From: James Duffy
Sent: 22 August 2025 15:30
To: Roger Flowerday; Oliver Sowerby; Adrian McHale
Cc: Reiss Sadler; Gary Stephens; Sally Miller; Tom Thornewill; Steve Fraser-Lim
Subject: Buntingford (Land North of A507) - Agreed further highway information
Attachments: FW: 3/24/0966/OUT - Land North of A507, Buntingford Consultation Response; Landscape and Visual Impact Assessment Addendum - Appendix A Figure L6 (3).pdf; 23161_SK_T_034 (P2) Proposed Widening of PROW 36.pdf; 23161_SK_T_003 (P4) Active Travel Connection to Buntingford Village Centre.pdf; 23161_SK_T_029 (P3) Baldock Road Roundabout - Northern Access.pdf; 23161_SK_T_023 (P8) Forward Visibility Plan.pdf; Buntingford LHA response to June 2025 comment - Final with agreed actions and response v4.xlsx

PROJECT:
BUNTINGFORD

PROJECT REF: 23161	STATUS: N/A
DRAWING No: 029	REV: P3

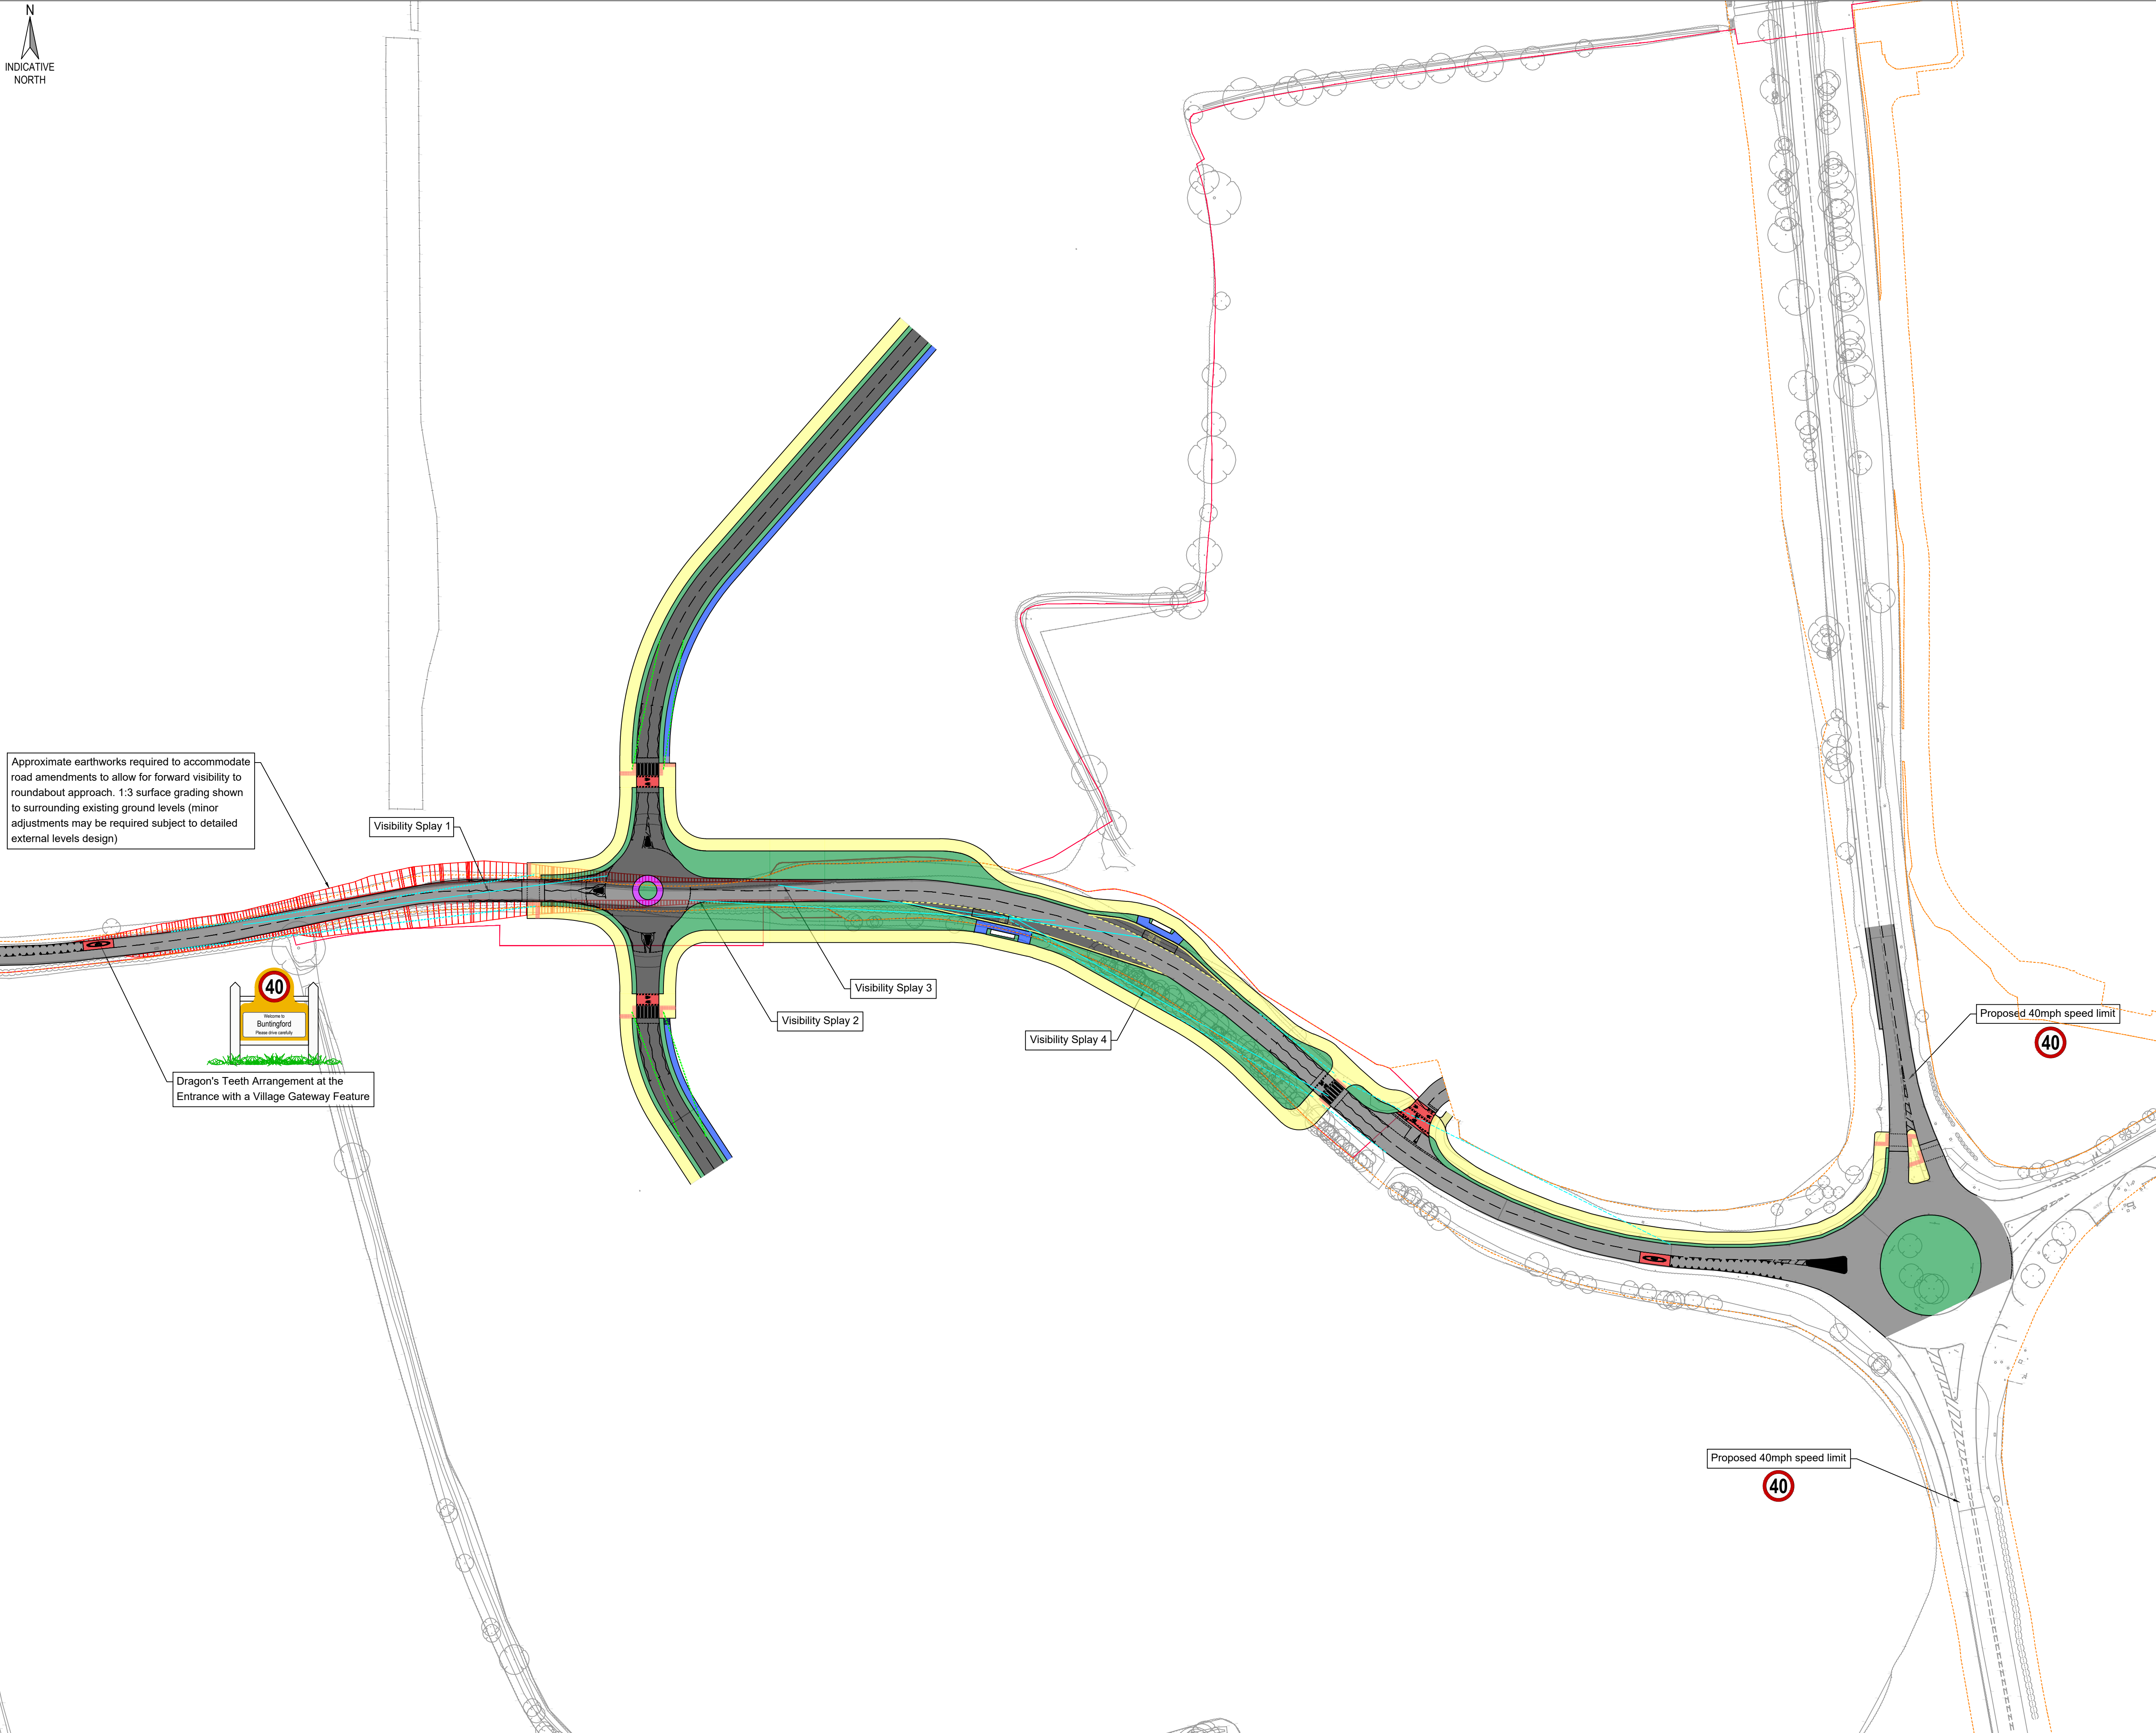
Baldock Road active travel	"The principal route into Buntingford via Baldock Road may not be made compliant with LTN 1/20 and introduces traffic calming that may not be considering fitting for this key link."	The proposed links are appropriate for the likely demand. LTN1/20 indicates in Table 6-3 that a 3m width shared pedestrian / cycle route has capacity for 300 pedestrians and 300 cyclists per hour. In addition, the additional active travel connections provided via the bridges over the A10 will also provide further capacity. Notwithstanding this, should the Local Highway Authority seek specific further improvements then we would consider feasible options. The traffic calming measures can be reviewed in discussion with the Local Highway Authority and alternative treatment can be considered if required.	The LHA have confirmed that the following should be considered for the links on Baldock Road east of the A10 (subject to considerations of highway land / requirements to maintain bus access on Baldock Road): - Where possible, and if feasible, seek to continue the shared route on the eastern side of the A10 on one side of the road (rather than switching to the other side) - Look to tighten bell mouth junctions on the wide junctions - Space can be transferred from carriageway to active travel (for example on side roads) as long as this does not impede bus access - Investigate active routes on Bowling Green Lane from Baldock Road to public car park with potential for contributions to bike parking - Whilst traffic calming is not specifically objected to other measures such as carriageway reapportionment may achieve better results in terms of improving environment for active travel users This design will therefore be reviewed by Jubb (now Ridge). On the western side of the A10 the LHA have confirmed that shared use (rather than segregated cycling) would be more appropriate as this would provide consistency with the eastern side. They confirmed that this could still be a 5m corridor but with 4m as shared use path and 1m as highway verge. This design will therefore be reviewed by Ridge.	The drawing showing enhancements on Baldock Road has been updated to include the following: -tightened junctions on side road Bellmouths and improved crossings over these roads -reallocation of space from the carriageway on Bowling Green Lane where feasible to provide a continuation of active travel into this road. This still retains a 5.5m carriageway in this area. In addition, financial contribution to cycle parking can be provided to enable further provision to be provided in Bowling Green car park - It is noted that the highway boundary on Baldock Road switches sides across the length and therefore it is not possible to maintain a corridor on one side but crossing is minimised The changes are set out in drawing 23161 003 P4. The northern access plan (drawing 23161 029 P3) and cumulative access plan (drawing 23161 023 P8) have been updated to include a 4m shared pedestrian / cyclway as requested with an associated 1m landscape strip.

- 23161 029 P3 – Showing the connection for the residential only proposals onto the A507, which now shows the revision to the 4m shared pedestrian / cycle route as requested with at least 1m landscape strip
